C.C. AIRPORT PAVEMENT REHABILITATION APRON SLAB REPLACEMENT PHASE II

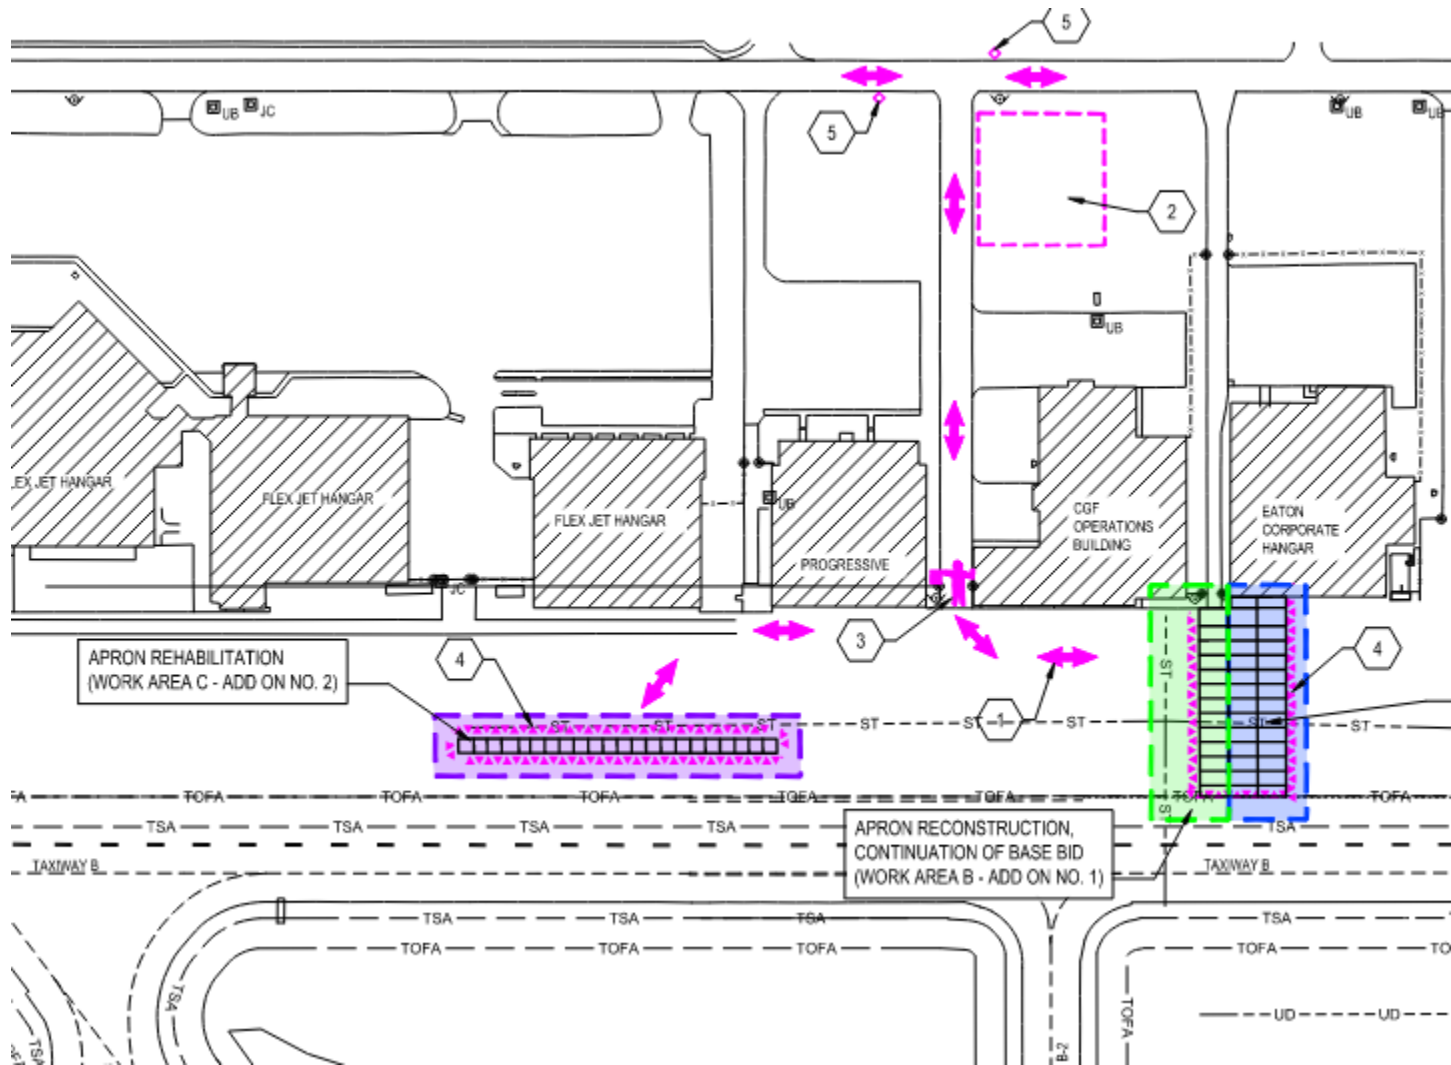
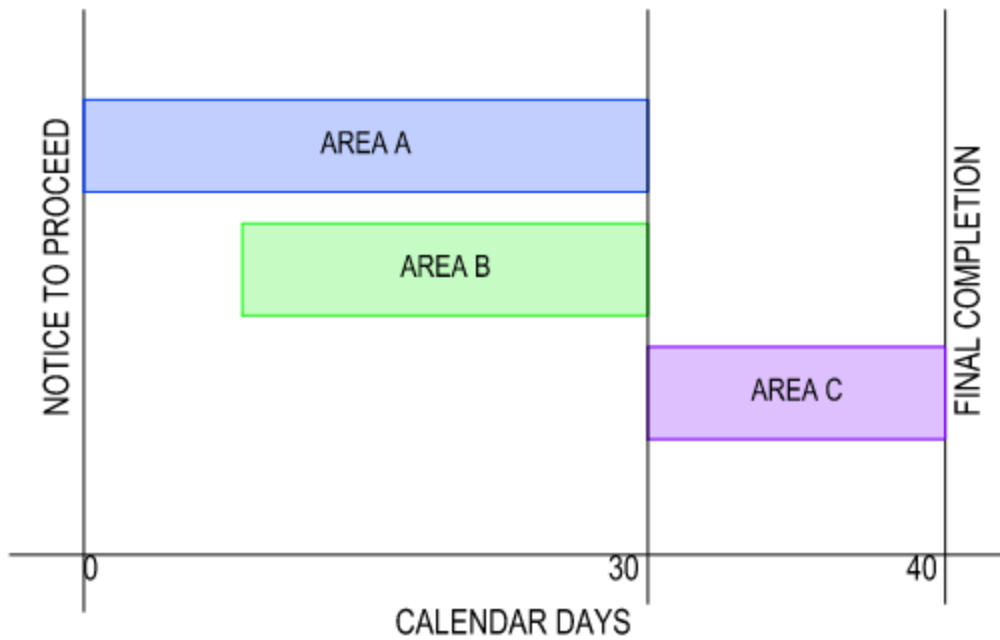
1. Is a crushed and screened recycled concrete an acceptable material for Item P-154 Subbase?

They can use crushed concrete as P-154 as long as it:

1. Meets the gradation requirements in the table shown in the spec; and
2. has a CBR value of at least 20 when tested in accordance with ASTM D1883 using a surcharge load of 25 lbs.
